Appendix J

CARs

CORRECTIVE ACTION REQUEST NO. :CESPK-ED-GG-FY07-0001	
Originator: Lewis Hunter	Date Issued: 27 March 2007
Issued to: Kevin Siemann, Shaw Project: Former Ft Ord, MRS-16 Clean-up CESPK Project Manager: Cynthia Burris CESPK Project Safety Officer: Clinton Huckins Response Due: 3 April 2007	
Description of Condition Found: (As observed or reported)	
<p>QA seed Ord QA29 was detected and recovered on 3/15/07. This seed was planted as a double seed with a second seed buried 6" below. The second seed, Ord QA08 is a 37mm planted horizontally that was buried below QA29. QA08 by itself is undetectable from the surface but should have been detectable with a Schonstedt from the bottom of the hole when QA29 was removed.</p>	
<p>(Appropriate personnel, i.e. contractor PM, Safety Officer, Team Leader, etc., receiving the CAR will provide the following information to the originator by the "Response Due" date above. Please contact the originator if you have any questions)</p>

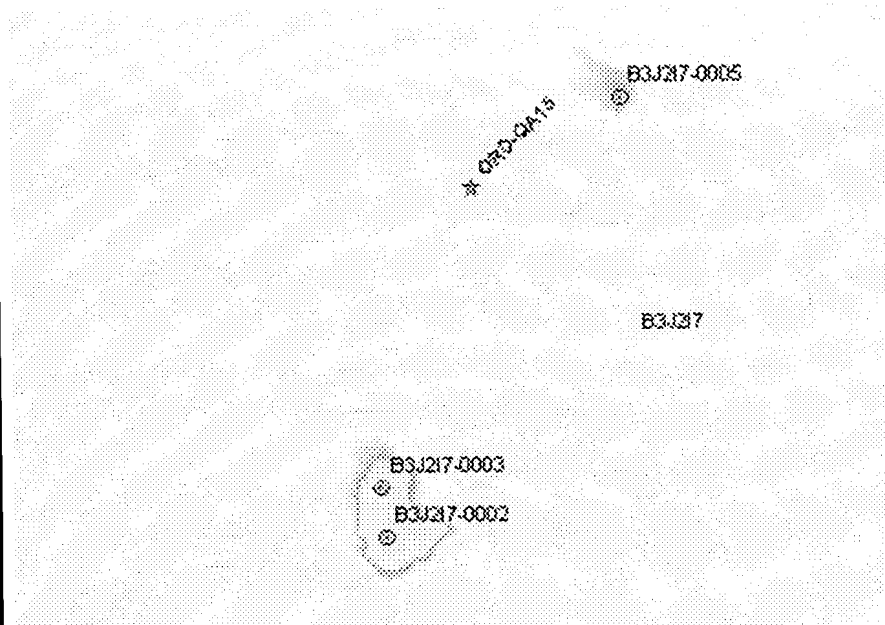
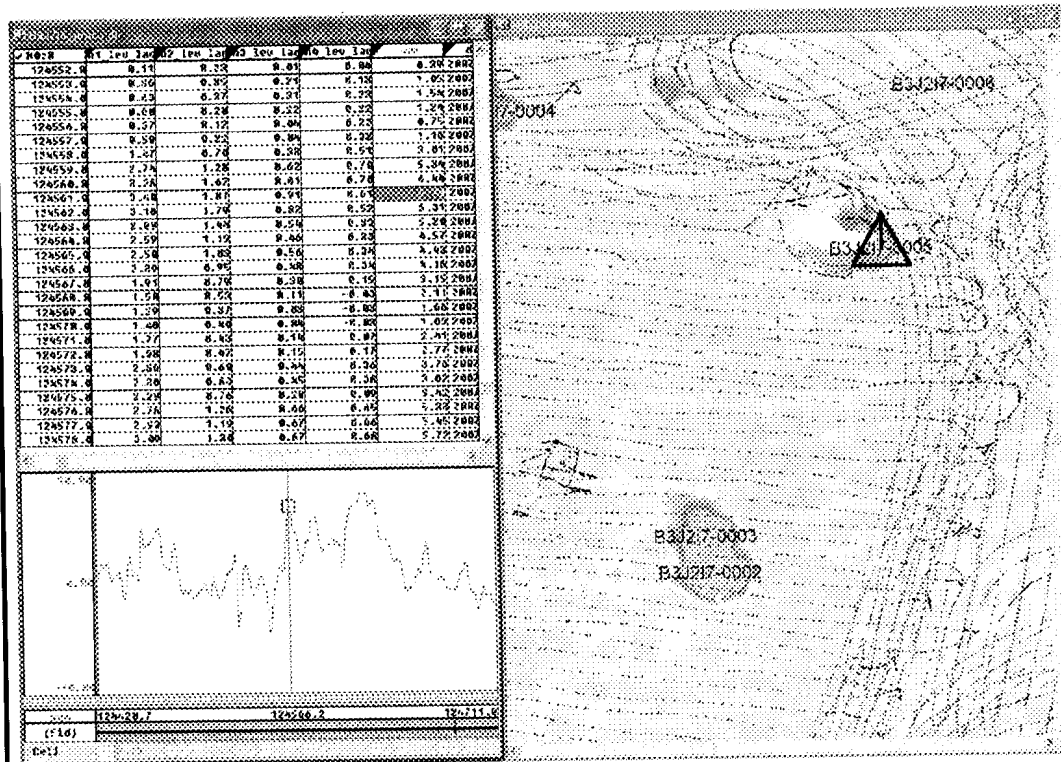
QA seed missed in grid B3J2I7 resulting in failure of grid block in which it was collected.

ORD-QA15 is a 37mm round buried vertically with a depth of 15-in. The nearest pick is B3J2I7-0005 located more than 10-ft to the northeast. Item was not detected by the DGM survey.

Although CAR 3 does not give coordinates of the QA seed we believe the QA seed is located as shown below in proximity to two other anomalies shown in the CAR 3 map above. The location is shown under the cross-hair point slightly more than 10 feet south west of anomaly B3J2I7-0005 in map below. The EM61Mk2 response is 6.79 mV. This is below the pick threshold. Since we have detected and picked all of the other QA seeds it is unlikely that the equipment couldn't detect this QA seed. Therefore the explanation is complex. Since the data and anomalies throughout the rest of the grid are acceptable and consistent we don't believe there was an equipment malfunction. The tracking data also show good coverage. It may be possible that the QA seed settled or has been shifted by animal activity.

It would be recommended that we bring a single new EM61 Mk2 system to see if the QA seed is detectable at the project threshold. If it is not detectable then the depth of the seed needs to be examined. We also need to confirm the exact location of the QA seed item by getting the coordinates.

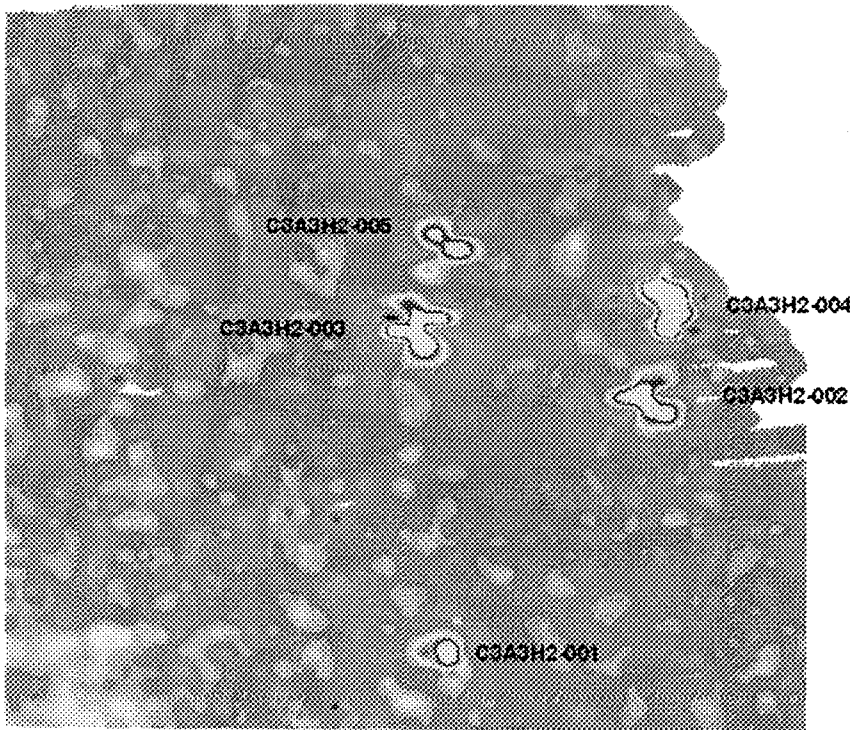
Grid block C3A3H2. 5 anomalies above pick thresholds were identified following QA digital surveys. Dig results found:

Status: QA grid failure

After plotting the locations of the anomalies detected in the QA mapping of grid C3A3H3 Shaw noticed that there were no anomalies for 4 out of the five locations indicated in the QA data (anomalies 2,3,4, and 5 - see above figure). Anomaly 1 is located in a cluster of anomalies and may represent one of the anomalies. We also noticed that all of the anomaly locations, when shifted 10.5 feet to the northwest, fall on top of one of the mapped anomalies. Many times anomaly clusters displaced by the same amount are caused by GPS problems (ergo: one cause can be lack of correction to position from a base station). This caused Shaw to look at the GPS in detail.

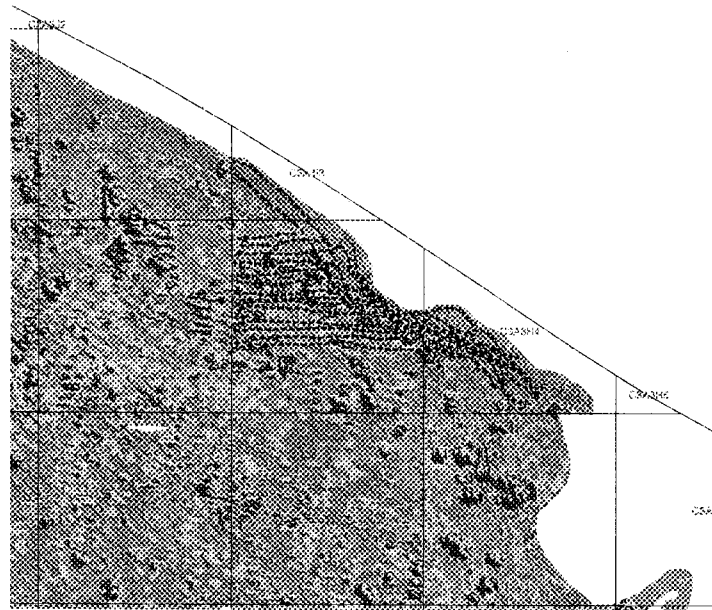
The next step that Shaw conducted was to extract the raw GPS files (before it enters MagLog) to determine if GPS lock quality can be extracted from the raw files. Raw GPS files do have an indicator of GPS lock quality. Each data point has an associated number (from 1 to 4). Number 1 indicates that the RTK GPS is "out of lock" and represents an uncorrected (no RTK) GPS location. Numbers 2 through 4 indicate that RTK GPS is "in lock" with increasing accuracy (even a 2 is within standards). Numbers 2 through 4 represent corrected GPS locations (RTK is working). Shaw then wrote a program to examine the raw GPS files for the numbers associated with the lock accuracy of a given raw GPS file. Shaw found that the data on 3/21/07 had some number 1 (out of lock) data. Approximately 1/16th of the data collected that day was affected by loss of lock. That area affected also correlates directly with the area where the anomalies were found during the QA inspection.

The action taken to correct the occurrence is to conduct a re-survey in the areas affected by the loss of lock. This can be done in real-time with the EM-61 Mk2. Most of the other anomalies in Grid C3A3H3 have been excavated in C3A3H3 (excavated from "good lock" data in the rest of the grid). However, the affected "no-lock" area does extend slightly onto the two adjacent grids and covers a very minor part of those grids. Those areas should be surveyed. Anomaly 1 from the QA data in Grid C3A3H3 falls outside of the "no lock" area. The anomaly falls in an area where several anomalies are clustered and is likely the result of inadequate field QC.

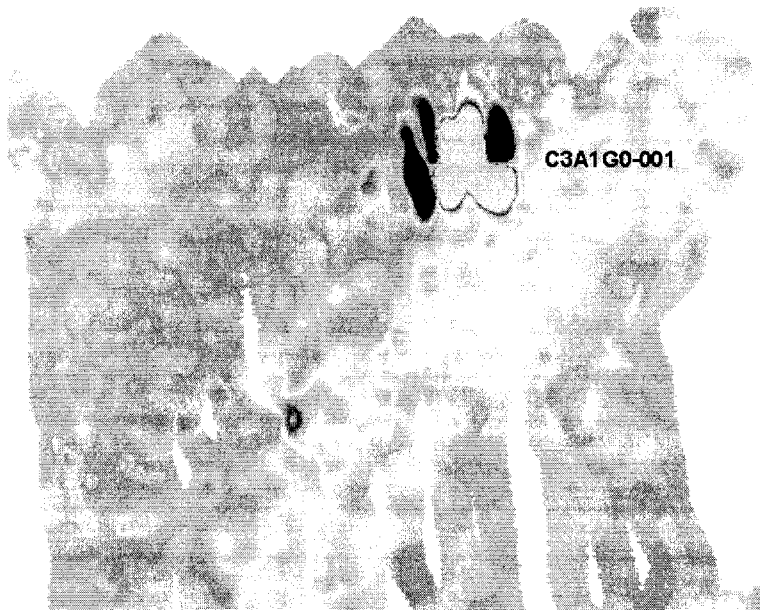
Grid block C3A1E0. 1 anomaly above pick threshold identified following QA digital surveys. Dig results found:

Status: QA grid failure

Actual Cause: (Appropriate personnel will investigate and determine cause of condition reported above. Actual cause should be stated as specifically as possible).
Target lies outside of the recently removed fenceline in grid C3A1H0. Real-time EM61 survey was completed along fenceline following fence removal, but did not extend beyond fenceline in accordance with FWV 0024.
